**[Docket No. 99-CE-85-AD; Amendment 39-12917; AD 2002-21-11]**

### **Airworthiness Directives; EXTRA Flugzeugbau GmbH Model EA-300S Airplanes**

**ACTION:** Final rule.

Figure 1

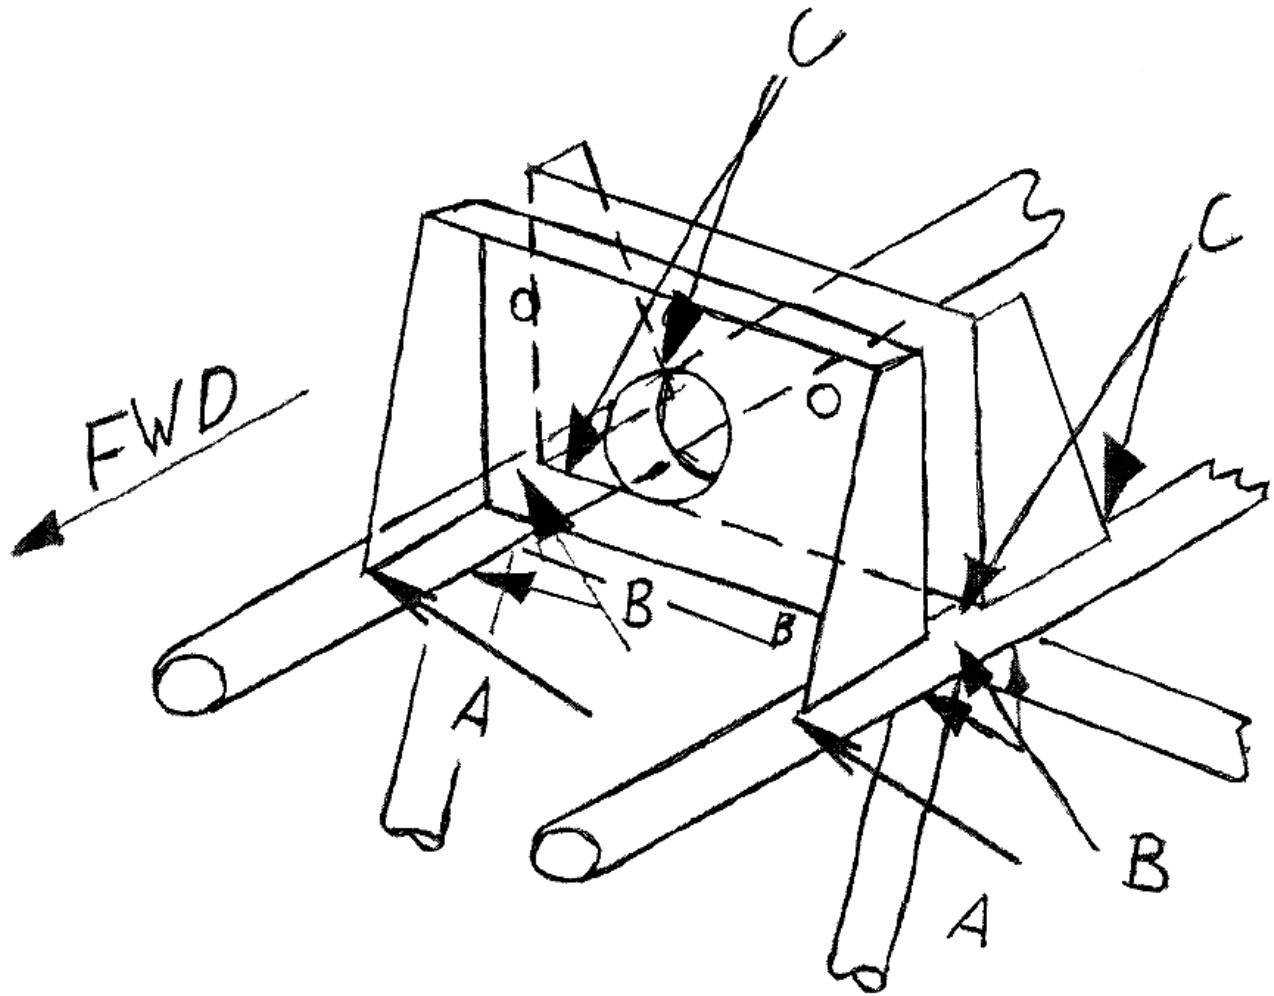
<b>Actions</b>	<b>Compliance</b>	<b>Procedures</b>
(1) For all affected airplanes, inspect, using a fluorescent dye penetrant method, the upper longeron at the horizontal stabilizer attachment for cracks in the areas depicted in Figure 1 of this AD.	Upon accumulating 250 hours time-in-service (TIS) or within the next 50 hours TIS after December 17, 2002 (the effective date of this AD), whichever occurs later.	In accordance with Part I of Extra Service Bulletin No. 300-2-95 (pages 2-6 at Issue: C, dated July 15, 1998; and pages 1 and 7 through 11 at Issue: D, dated January 30, 2001). No further action is required by this paragraph if the modification is already accomplished in accordance with Part II of Extra Service Bulletin No. 300-2-95 (all pages at Issue: C, dated July 15, stabilizer 1998).

<p>(3) For all affected airplanes, if any crack is found during the inspection required by this AD and the cracks(s) is (are) in Area A or Area B as depicted in Figure 1 of this AD, accomplish the following:</p> <p>(i) Repair and modify the upper longeron at the horizontal stabilizer attachment; and</p> <p>(ii) Weld the cracks tight during repair.</p>	<p>Prior to further flight after the inspection where any crack is found in Area A or Area B as depicted in Figure 1 of this AD.</p>	<p>In accordance with Part II of Extra Service Bulletin No. 300-2-95, Issue: D, dated January 30, 2001. No further action is required by this paragraph if already accomplished in accordance with Part II of Extra Service Bulletin No. 300-2-95 (all pages at Issue: C, dated July 15, 1998).</p>
<p>(4) For all affected airplanes, if any crack is found during the inspection and the crack(s) is (are) in Area C as depicted in Figure 1 of this AD, accomplish the following:</p> <p>(i) Obtain a repair scheme from the manufacturer;</p> <p>(ii) Incorporate this repair scheme; and</p> <p>(iii) Accomplish any follow-up actions as directed by the FAA.</p>	<p>Prior to further flight after the inspection where any crack is found.</p>	<p>In accordance with a repair scheme obtained from EXTRA Flugzeugbau GmbH, Flugplatz Dinslaken, D-46569 Hünxe, Federal Republic of Germany; telephone: (0 28 58) 91 37-00; facsimile: (0 28 58) 91 37-30. Obtain this repair scheme through the FAA at the address specified in paragraph (g) of this AD.</p>
